**STAFF REPORT**  
**(One-Step Final Plat)**

**CASE NUMBER:** SUB 2001-101 -- ERNEST JORDAN ADDITION

**LOCATION:** South of Maple, West of Hoover

**VICINITY MAP**

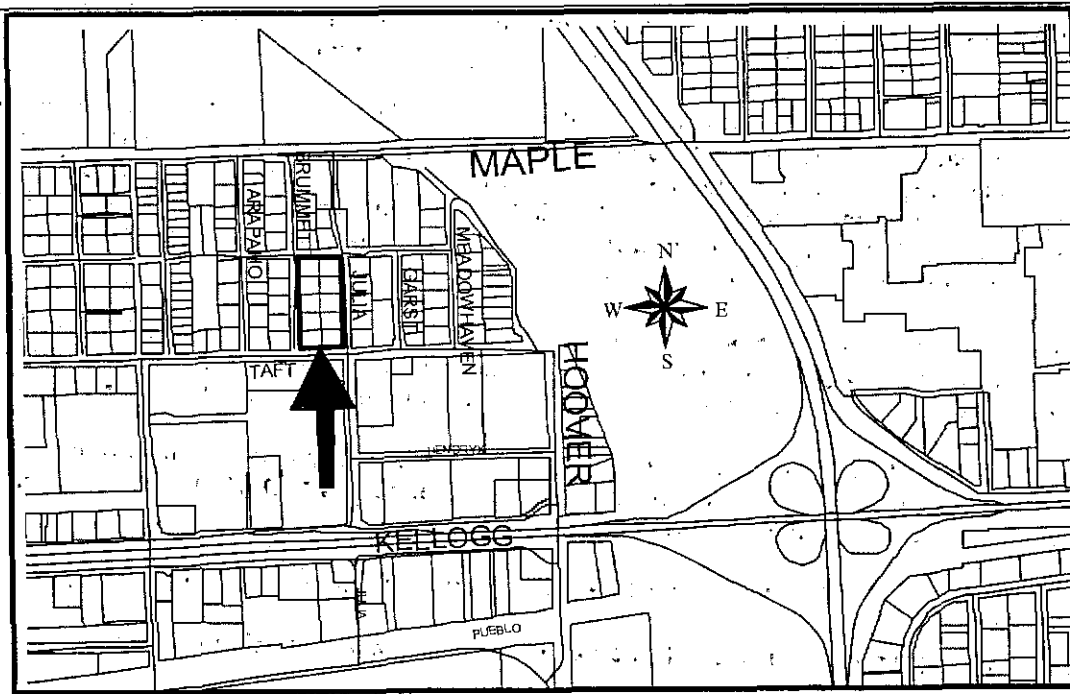
*Need to ext. SS*
